Appendix B **Technical memorandum
– water recycling plant
process and OEH
licence limits**

SUBJECT: Googong Township – Water Cycle Project – Environmental Assessment Responses

This memorandum has been prepared as a response to the comments of the Department of Environment, Climate Change and Water (DECCW) dated 21st Decmeber, 2010. The comments of DECCW have been review by MWH and areas applicable to the concept design are noted in this document.

Figure 1: Schematic of environmental discharge to Basin 4, utilising SBS dosing for de-chlorination.

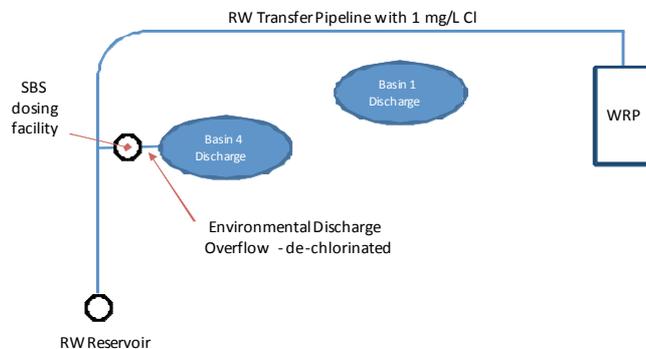
Small changes to the design configuration of the plant discharge arrangement and/or network will be required to meet the DECCW proposed 90th percentile free chlorine limit of 0.1 mg/L. We have identified two ways of meeting the licence requirement

The environmental water release strategy must be reviewed in order to achieve the DECCW recommendation of 0.1mg/L. Two options may be considered, de-chlorination using sodium bisulphite (SBS) or removal of the chlorination step for water which is to be sent to the environment.

1. De-chlorination

SBS may be used to bind free chlorine in the systems to a state where it is chemically inert. This SBS step is normally used for treatment plants that use chlorine for disinfection, then discharge to a river or stream. Introducing SBS will involve the design and construction of a chemical dosing facility at each of the environmental discharge locations. The current design shows a discharge point into

stormwater pond 1 for the early years of operation, and then a second release point at the top of Pond 4 once the full recycled water system is constructed.

Utilising SBS will allow for the currently proposed discharge locations to be maintained, without the need for additional transfer pipelines.

The dosing rate for de-chlorination is expected to be in the order of 5 kg of SBS solution per mega litre of water discharged to the environment. A schematic of the proposed SBS dosing scheme is given in Figure 1.

The ownership and operation of dosing outside of the plant may cause difficulties. For example, the specific location of the sample point must be considered in detail. The licence sample point must be located at Basin 4, in order for de-chlorination to be conducted at the Basin 4 discharge point. Utilising an off-site sample point may present significant operational difficulties in plant operation due to any changes in water quality, including any of the licence parameters, within the transfer pipeline. This issue must be considered further in choosing a de-chlorination option.
